ADDENDUM 3

ADDENDUM DATE: November 19, 2024

PROJECT: Onslow County Senior Services Center Renovation
4024 Richlands Highway
Jacksonville, NC 28540

ARCHITECT: Smith Sinnett Architecture, P.A.
4600 Lake Boone Trail, Suite 205
Raleigh, North Carolina 27607

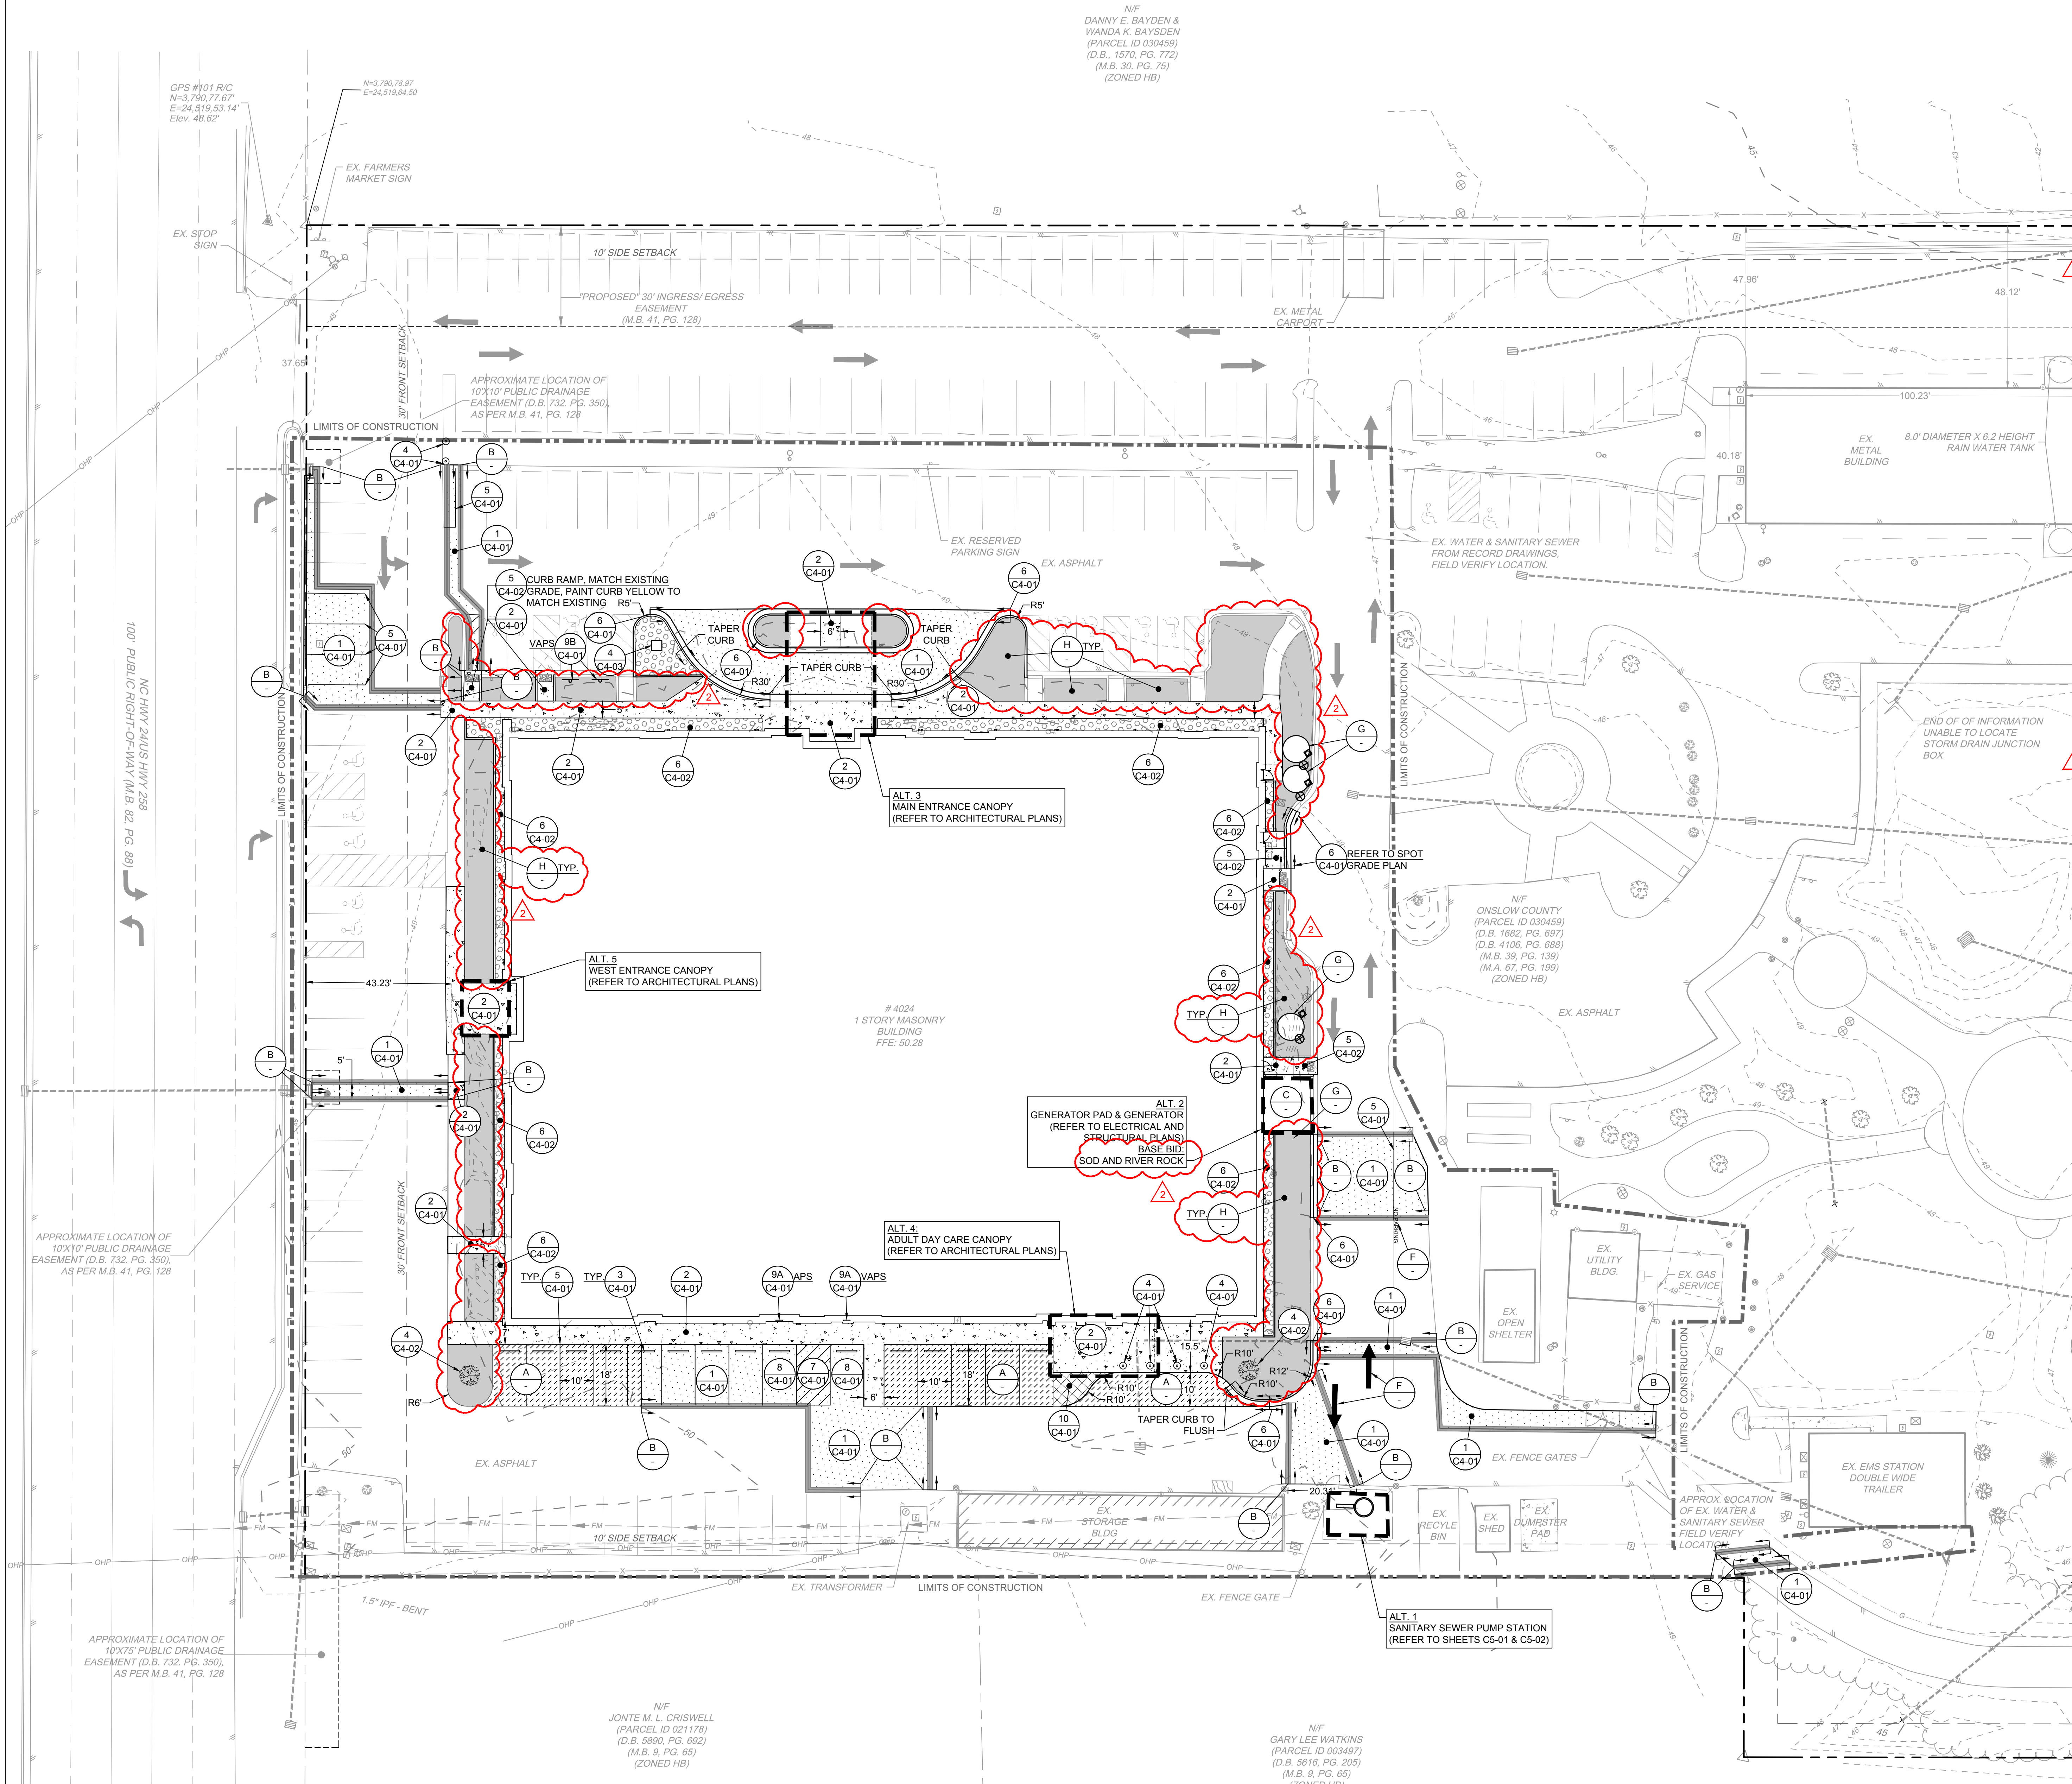
- Item 2 Contractor questions: "C2.01 references a seat wall on the architectural plans. Could you please confirm that a seat wall is part of this project?"
Response: Seat walls have been removed from the project. Refer to updated C2-01 attached to this addendum.

Response: Apart from the two Crepe Myrtles, the only landscaping on this project is grass. Refer to updated C2-01 attached to this addendum showing areas of sod. Follow the seeding schedule (on C4-03) in all other disturbed areas.

- Item 48 Sheet C2-01: REPLACE the sheet in its entirety with the attached sheet C2-01.
Note the following revisions:
- There are no seat walls in the project. Any reference to seat walls has been removed.
 - Apart from the two Crepe Myrtles, the only landscaping on this project is grass. See updated areas showing SOD as indicated on the plan.
 - Refer to seeding schedule on C4-03 at all other disturbed areas.

1 STRUCTURAL RENOVATION PLAN - AREA A
S1-01 1/8" = 1'-0"

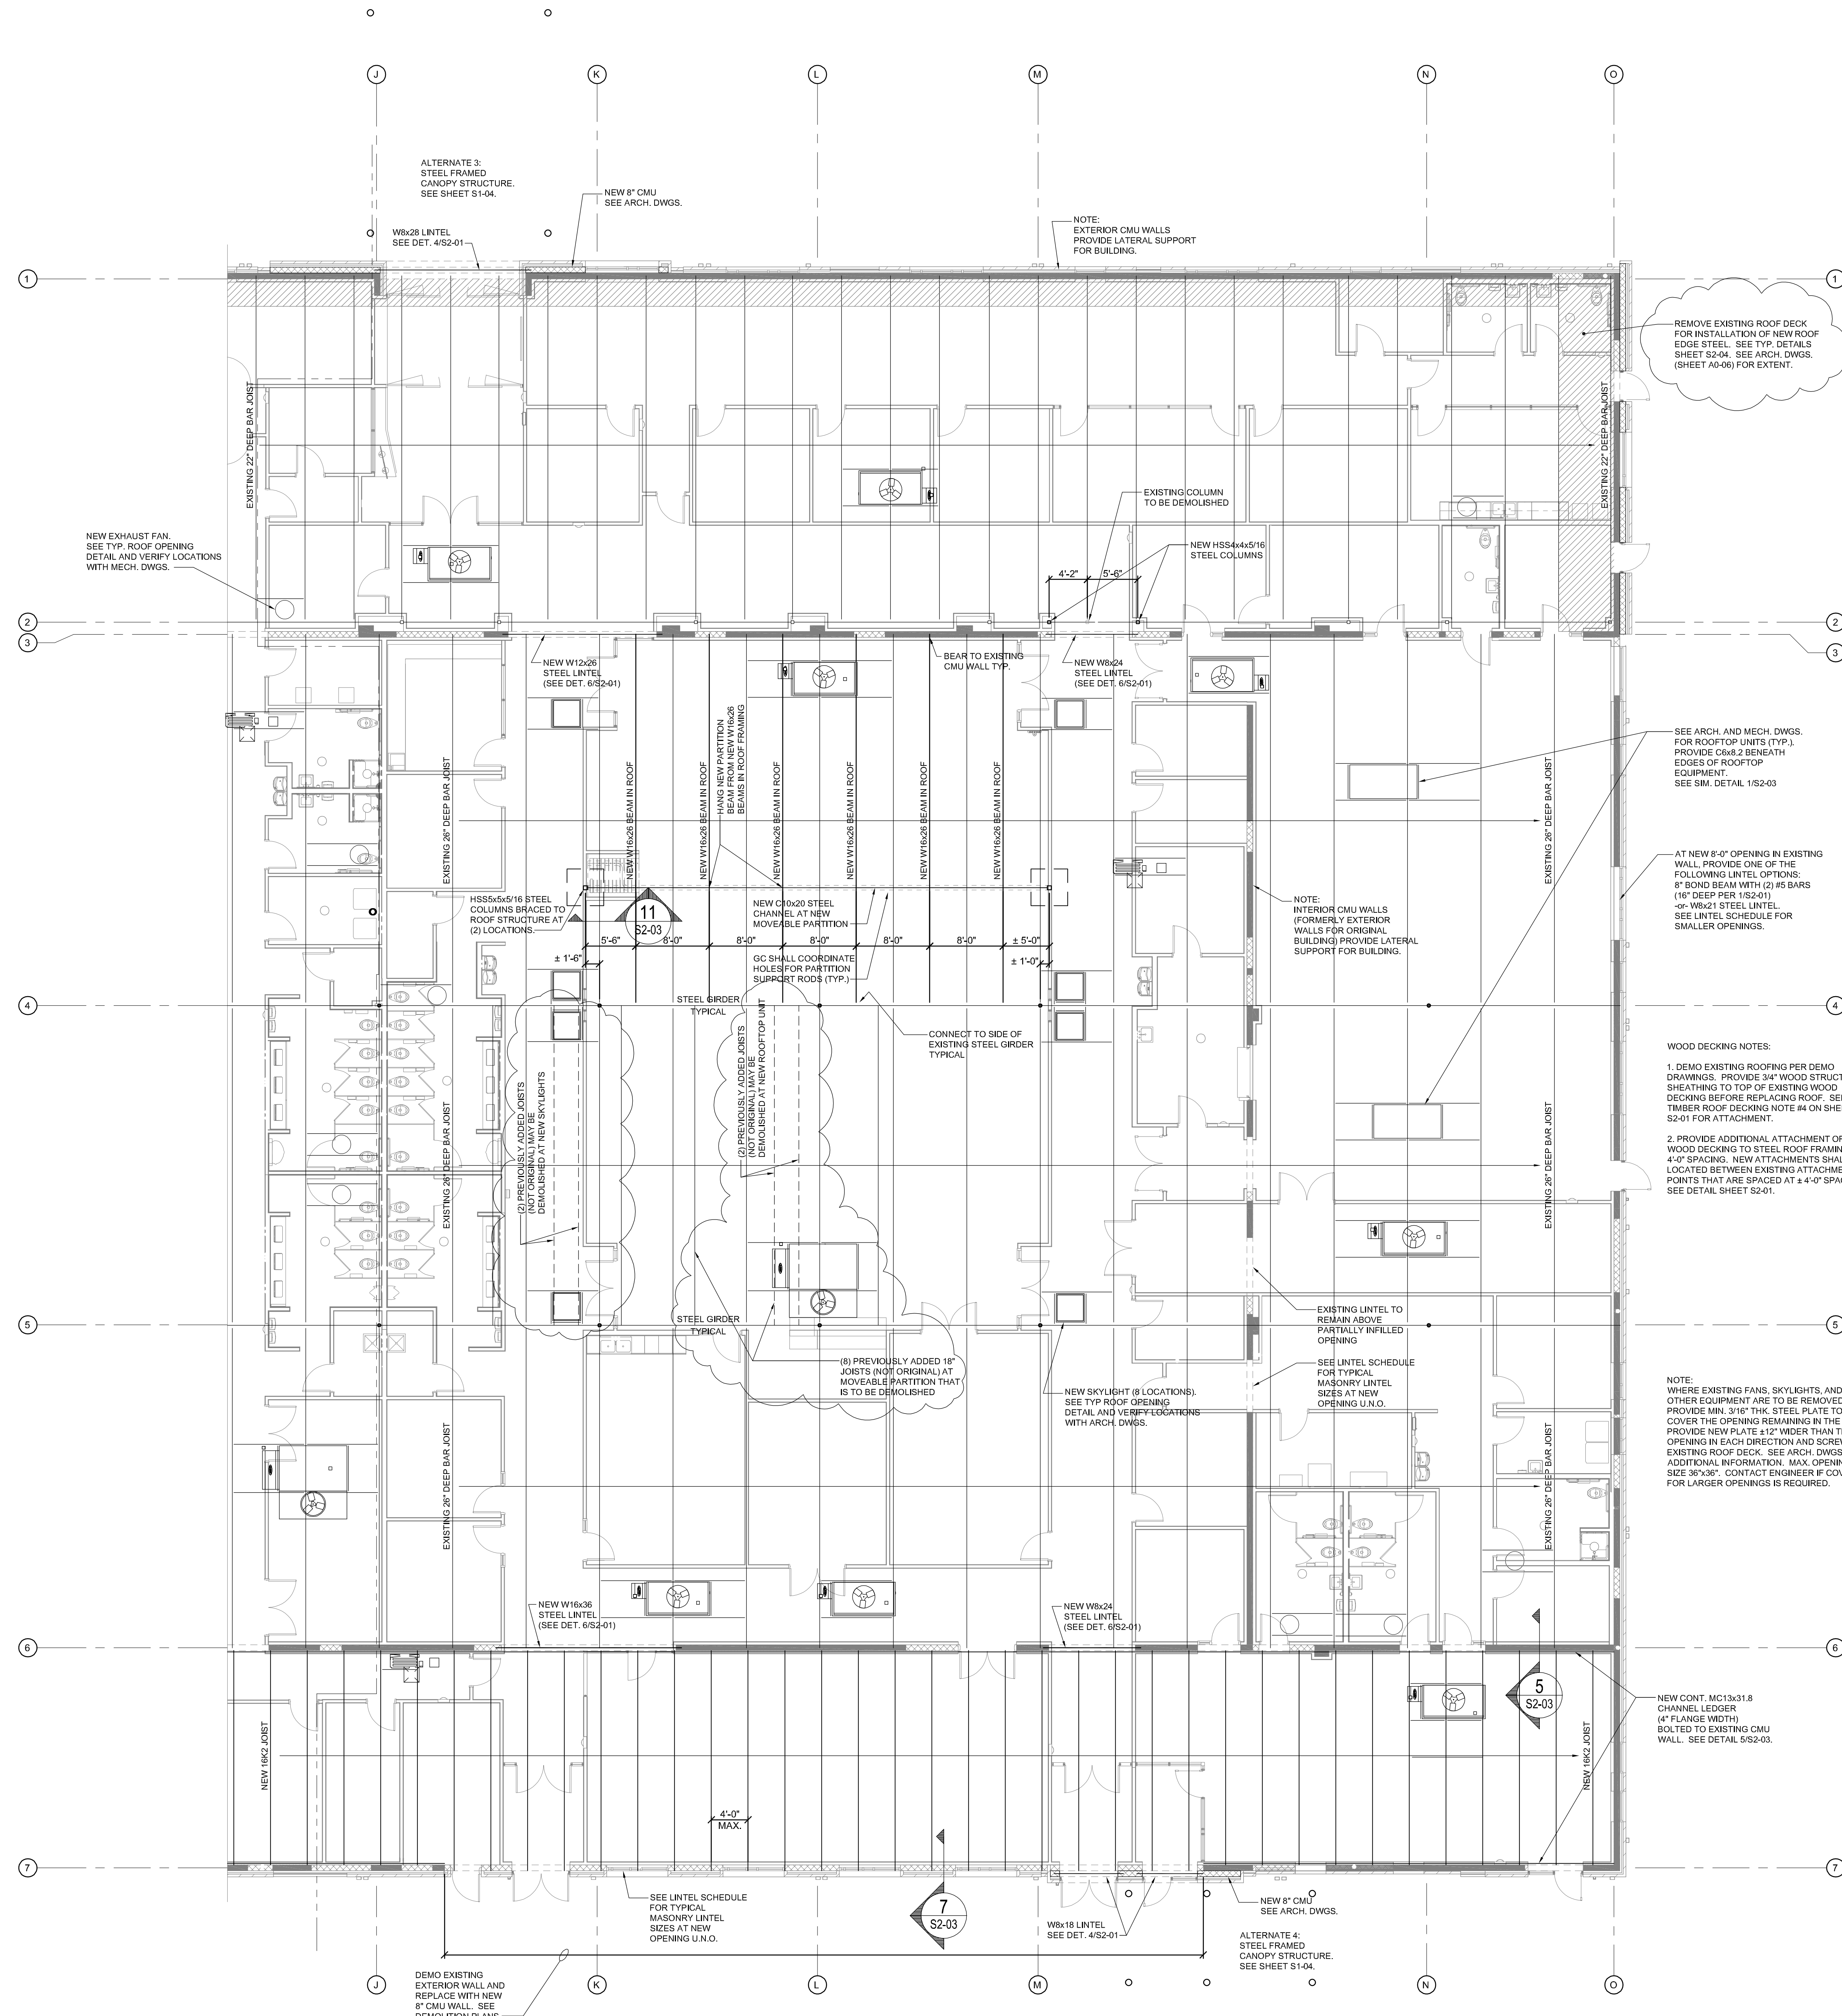
- Item 16 At the pre-bid meeting, a Contractor asked to clarify if the two open web joists with note "Previously added 18" joist (Not original) at moveable partition that is to be demolished" are be demolished?

- Item 17 At the pre-bid meeting, a Contractor asked to clarify the extents of demolition for roof deck at roof edge on S1-01.
Response: Refer to S1-01 and S1-02 attached to this addendum for clarification. Note the intent of demolishing the metal roof deck in these locations (north, partial east and partial west) is to install the new roof edge steel.

- Item 49 Sheet S1-01: REPLACE the sheet in its entirety with the attached sheet S1-01.
Note the following revisions:
- Existing joists at new skylights to be demolished.
 - Existing joists at new roof top unit to be demolished.
 - Extents of roof demolition at roof edge have been clarified.
- Item 50 Sheet S1-02: REPLACE the sheet in its entirety with the attached sheet S1-02.
Note the following revisions:
- Extents of roof demolition at roof edge have been clarified.
- Item 51 Sheet S1-03: REPLACE the sheet in its entirety with the attached sheet S1-03.
Note the following revisions:
- Column footings supporting roof framing associated with canopies per Alternate 3, 4 and 5 respectively shall be included with said Alternate as indicated on plan attached to this addendum.

Response: The two existing joists in the new Activity Room B 116 shall be demolished. Refer to S1-01 attached to this addendum for clarification of existing joists to be demolished.
